629-639 Pacific Highway, Chatswood – Gateway Determination Report

April 2021

Department reference number: IRF21/378

Figure 11: Draft Willoughby LEP 2012 Land zoning map (source: Willoughby City Council).

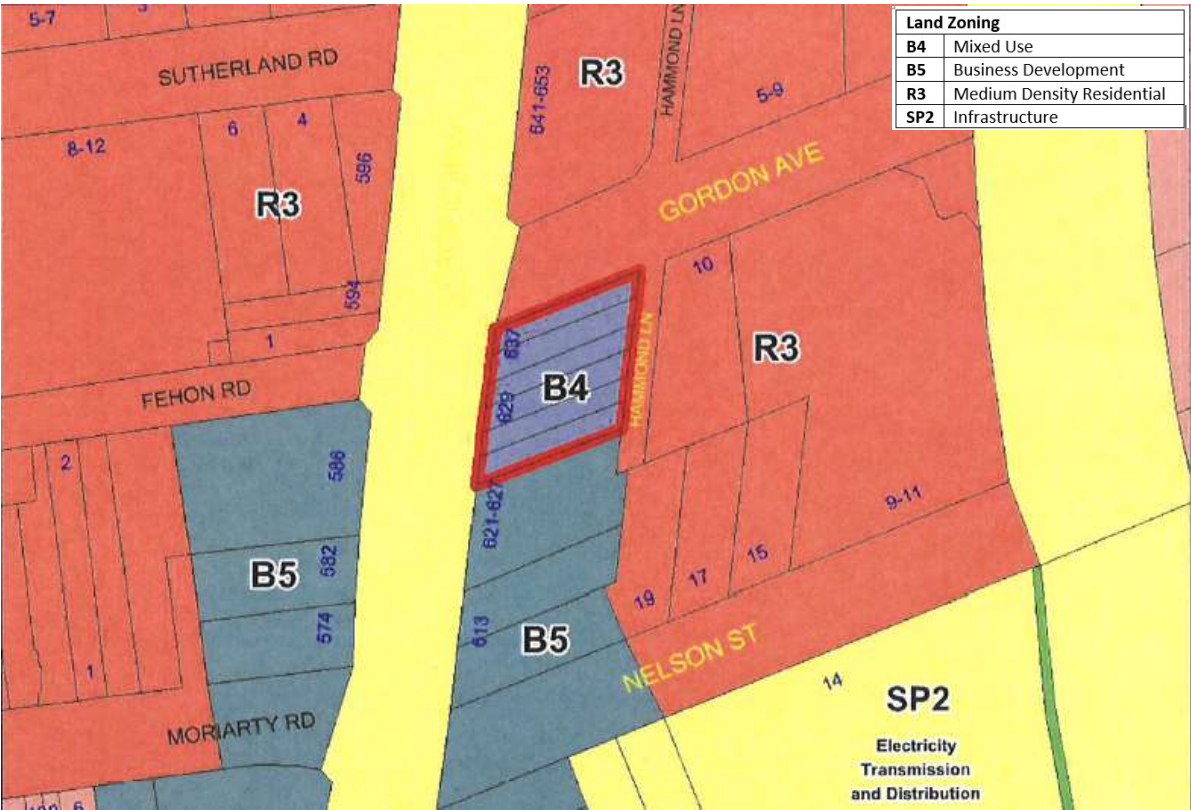
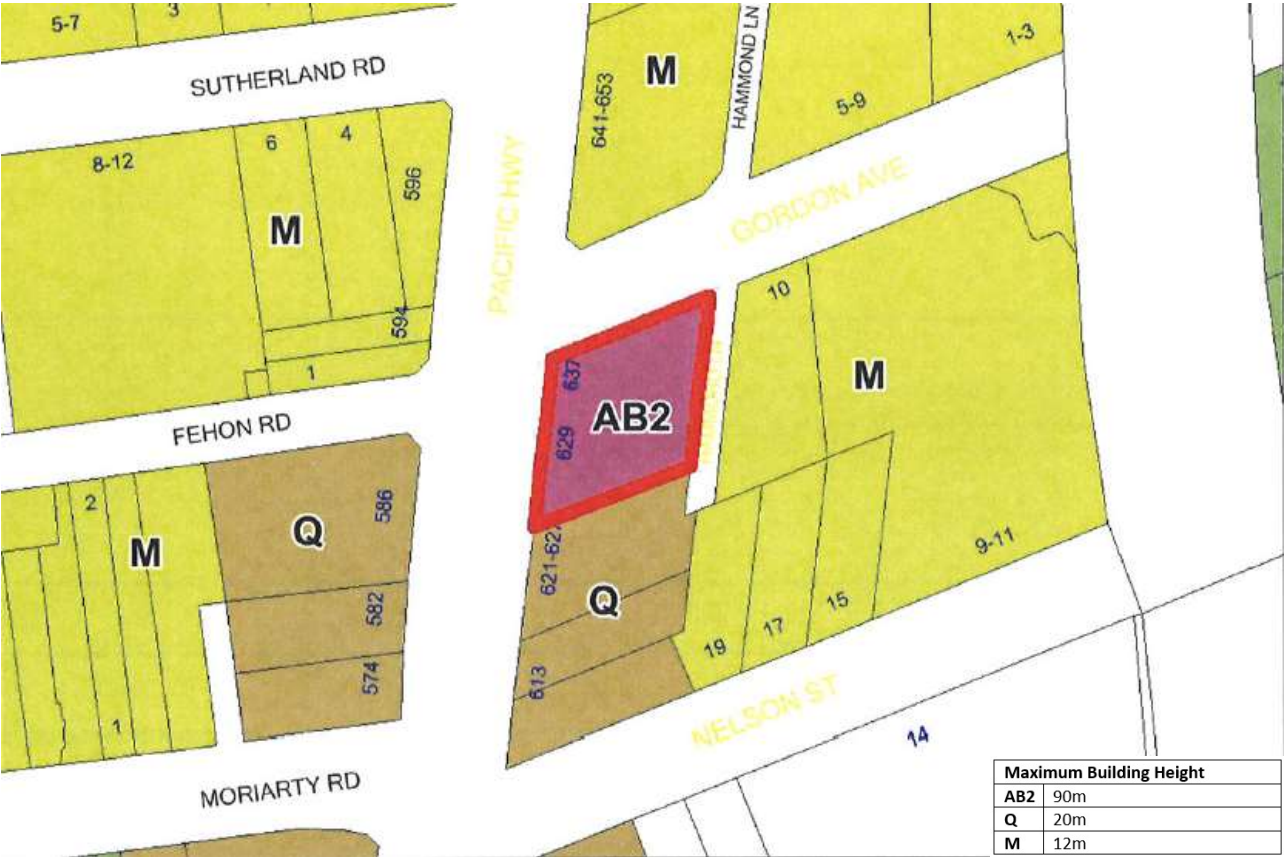
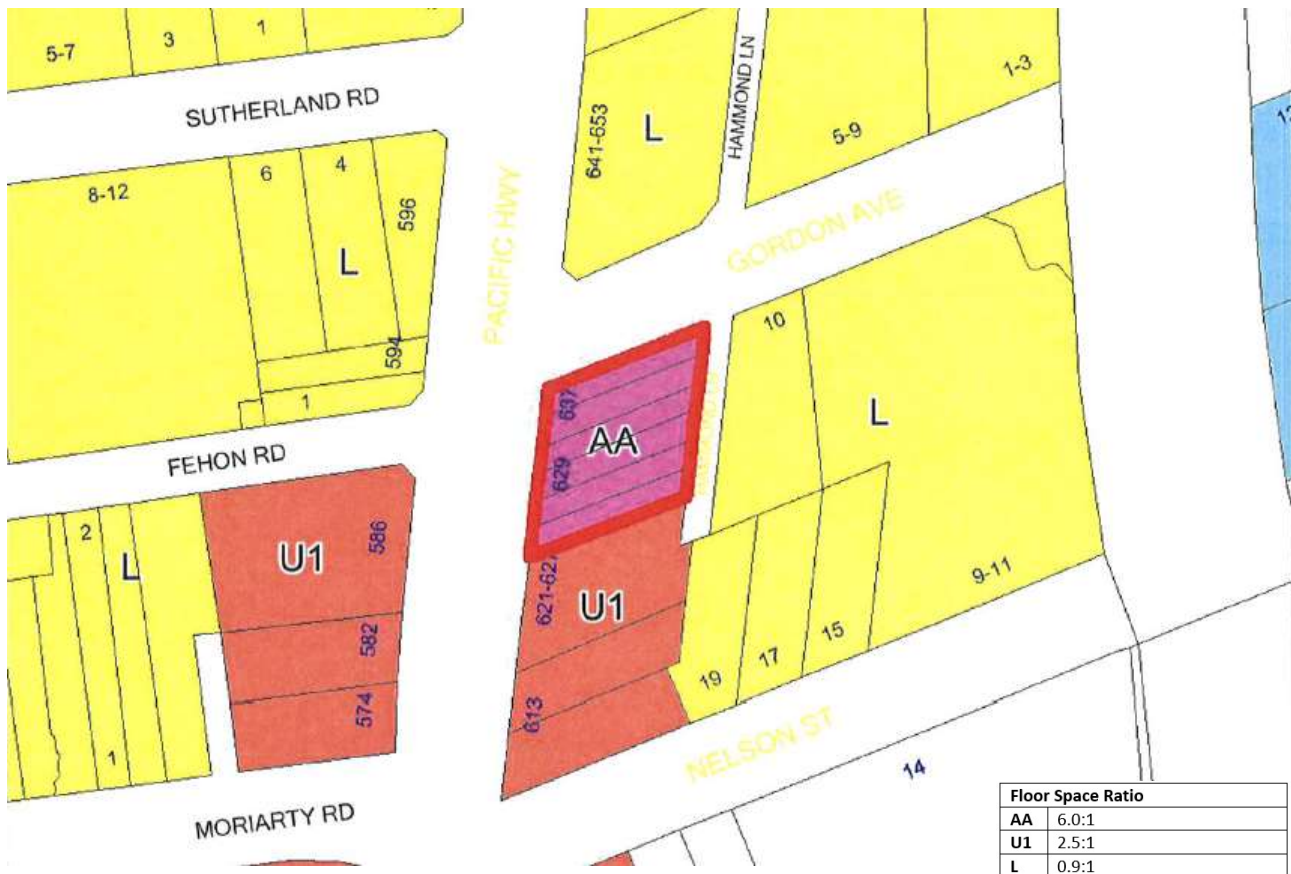
No changes are proposed to any other LEP maps. The maps submitted are considered appropriate for Gateway assessment and public exhibition. As previously noted, previous planning proposals within the Chatswood CBD that have proposed similar provisions relating to affordable housing, design excellence and minimum commercial FSR in accordance with the Chatswood CBD Strategy have updated references to site specific 'Areas' under the Special Provisions Map.

A Gateway condition is recommended to update the references on the Special Provisions Area Map prior to exhibition, to include the site and all corresponding clauses that will apply to it (eg. 'Area 9'- Affordable Housing, 'Area 11'- Minimum Commercial Floor space and 'Area 12'- Design Excellence). For the purposes of exhibition, the legend should reference the proposed control that would apply, and not only the specified clause.

Figure 16: Indicative ground and first floors (podium) showing updated commercial/retail GFA of 1,172sqm (source: DEM).

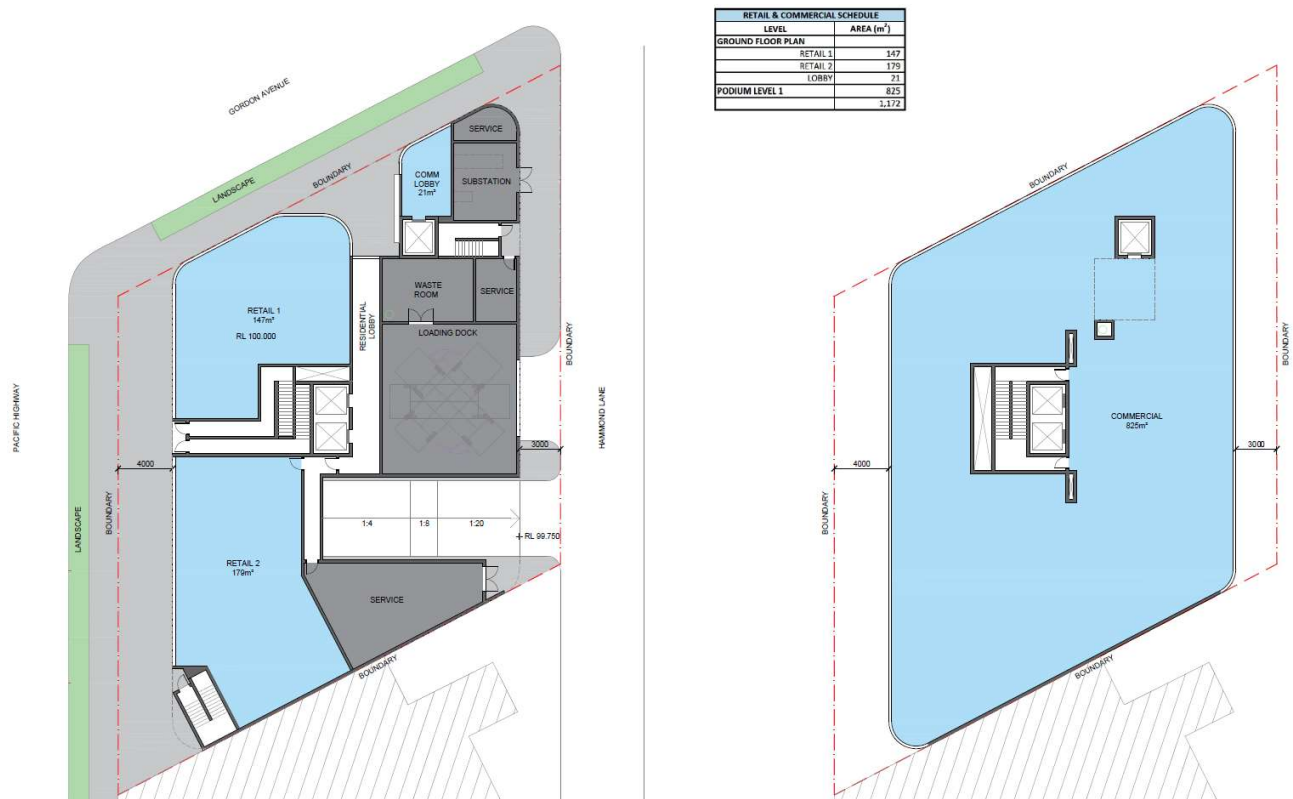
It is noted the concept design has since been updated to achieve a higher commercial/retail GFA (1,172sqm) to better align with the 1:1 minimum non-residential FSR provision proposed. The proposal will provide 347 sqm on ground floor and 825 sqm on Level 1 which equates to 0.99:1.

It is noted this estimate is based on the original Reference Design of 705sqm non-residential floorspace (refer to **Attachment A6**). The amended Reference Design, prepared in response to the Department's condition of endorsement of the Chatswood CBD Strategy, provides non-residential floorspace of 1,172sqm (refer to **Attachment A6**). This assumes the development is fully developed in accordance with the maximum FSR and minimum commercial FSR of 1:1 sought by the proposal. To this note, it is recommended the planning proposal report be updated to refer to the updated Reference Design that accommodates 1,172sqm non-residential floorspace.
